Re: Minor Modification of Resource Recovery and Protection Plan (R2P2), 1st Right Sub-Mains and Ventilation Portals, Hiawatha Seam, Deer Creek Mine

Subject: **RESOURCE RECOVERY AND PROTECTION PLAN [R2P2]
MODIFICATION REQUEST – INCLUSION OF THE PROPOSED
EXTENSION OF THE EXISTING 1ST RIGHT SUB-MAINS AND
REQUIRED LOCATION OF VENTILATION PORTALS IN THE RIGHT-
FORK OF RILDA CANYON; HIAWATHA SEAM; FEDERAL LEASE U-
06039; ENERGY WEST MINING COMPANY, DEER CREEK MINE.**

**1ST RIGHT SUB-MAIN EXTENSION
& PROJECTED PORTAL SITES
RIGHT-FORK RILDA CANYON**

**Request For
R2P2 (Resource Recovery and Protection Plan) Modification**

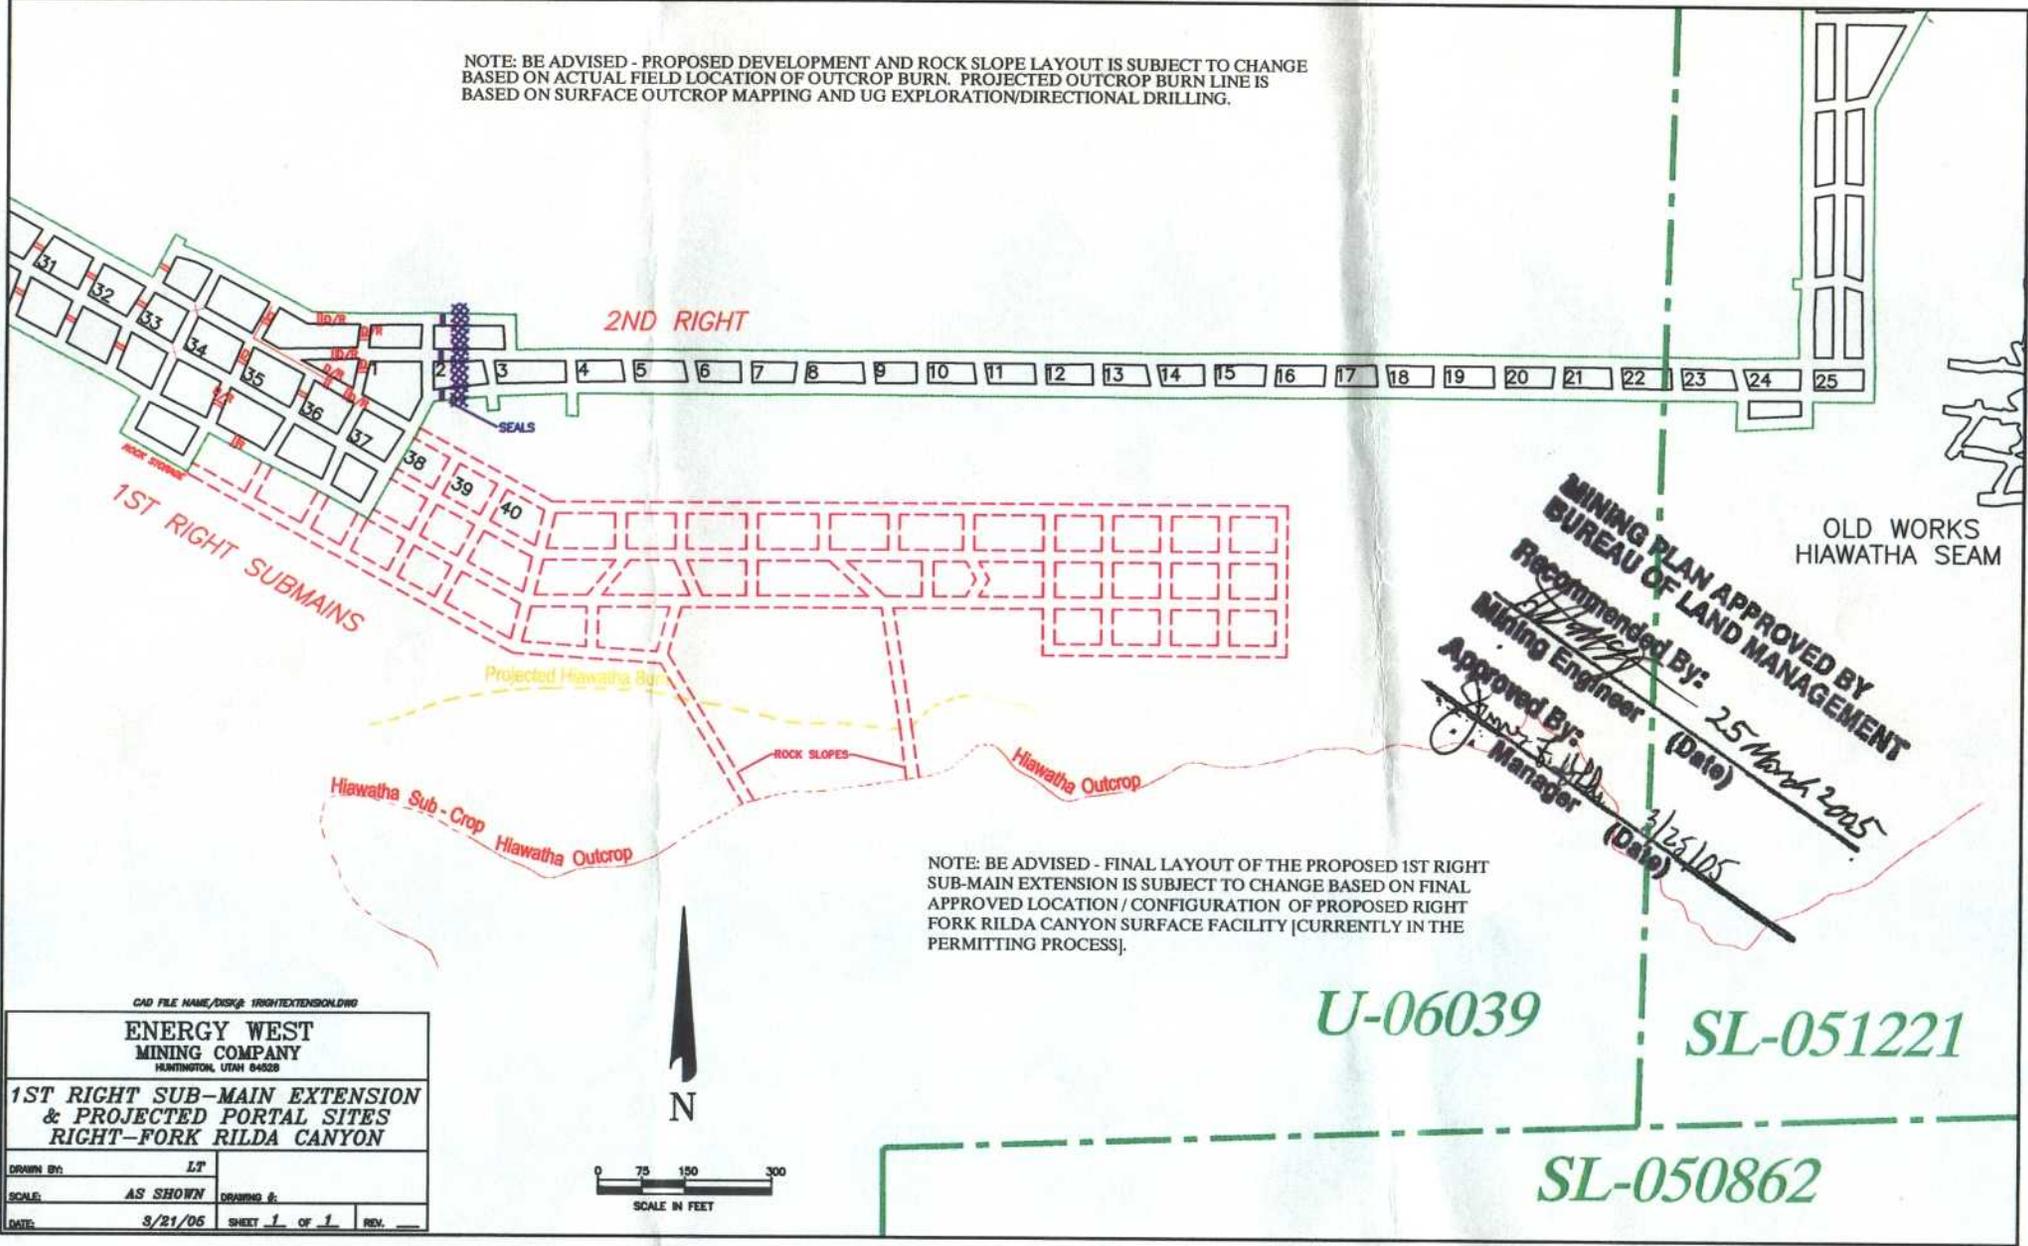
BLM approves development mining of the 1st Right Sub-Mains Extension with the planned rock slopes as shown. Should it become necessary to alter this configuration, PacifiCorp is required to consult with BLM and further modifications could be necessary. Should PacifiCorp store rock

from the rock slope drivages, the three (or more) entry access to coal remaining inby from the end of the 1st Right Sub-Main Extension will be maintained and not blocked with rock or other materials placed by the mine.

The modification to the R2P2, as depicted on mine map "1st Right Sub-Main Extension & Projected Portal Sites Right-Fork Rilda Canyon" is approved, contingent on the requirements stated above and pending State Permit approval. A copy of the approved mine map is enclosed. If you have any questions, please contact Jeff McKenzie of my staff at (801) 539-4038.

ENERGY WEST MINING COMPANY HUNTINGTON, UTAH 84528			
1ST RIGHT SUB-MAIN EXTENSION & PROJECTED PORTAL SITES RIGHT-FORK RILDA CANYON			
DRAWN BY:	LT / KP	DRAWING #:	
SCALE:	AS SHOWN	SHEET	1 OF 1
DATE:	3/23/05	REV.

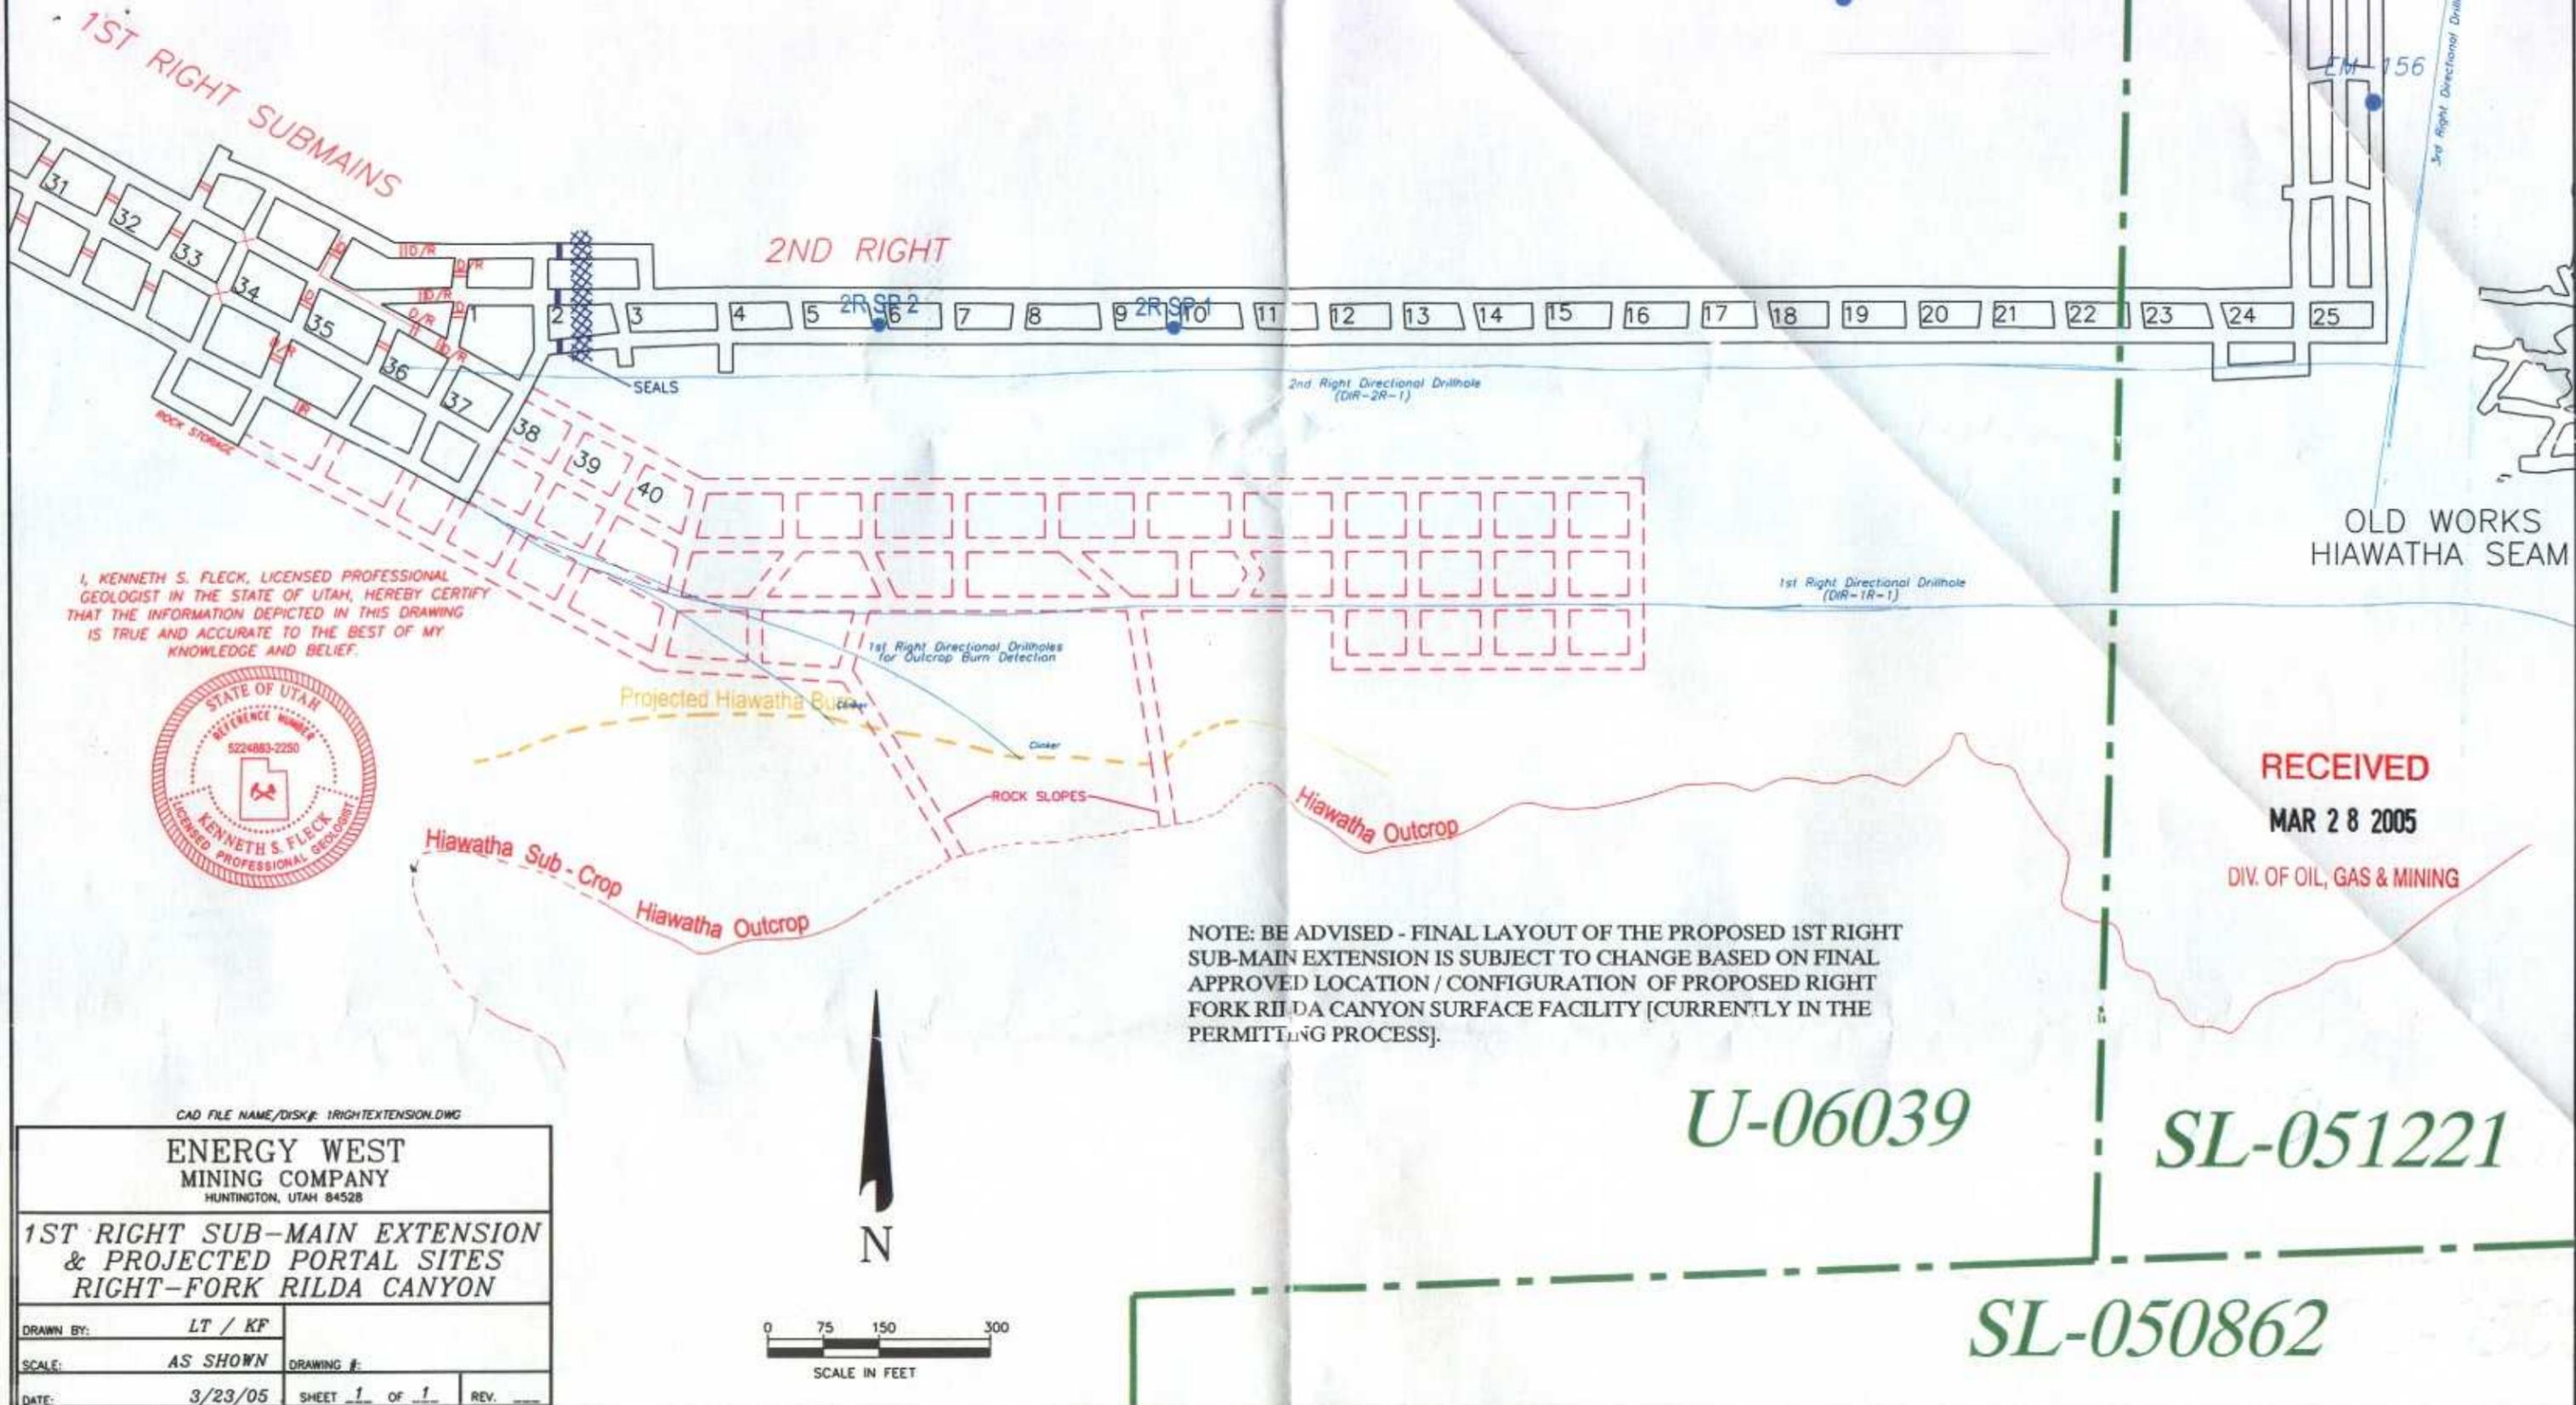
Describe Situation Leading to Request: As stipulated by the mine permit
modification process – the proposed mine workings, rock slopes and surface
portals included in the proposed permit modification request must be
included in the current approved mine resource recovery and protection plan.

Effect on coal recovery: Increase in development coal resource recovery
estimated at approximately +35,000 to +50,000 CM tons.

NOTE: BE ADVISED - FINAL LAYOUT OF THE PROPOSED 1ST RIGHT SUB-MAIN EXTENSION IS SUBJECT TO CHANGE BASED ON FINAL APPROVED LOCATION / CONFIGURATION OF PROPOSED RIGHT FORK RILDA CANYON SURFACE FACILITY [CURRENTLY IN THE PERMITTING PROCESS].
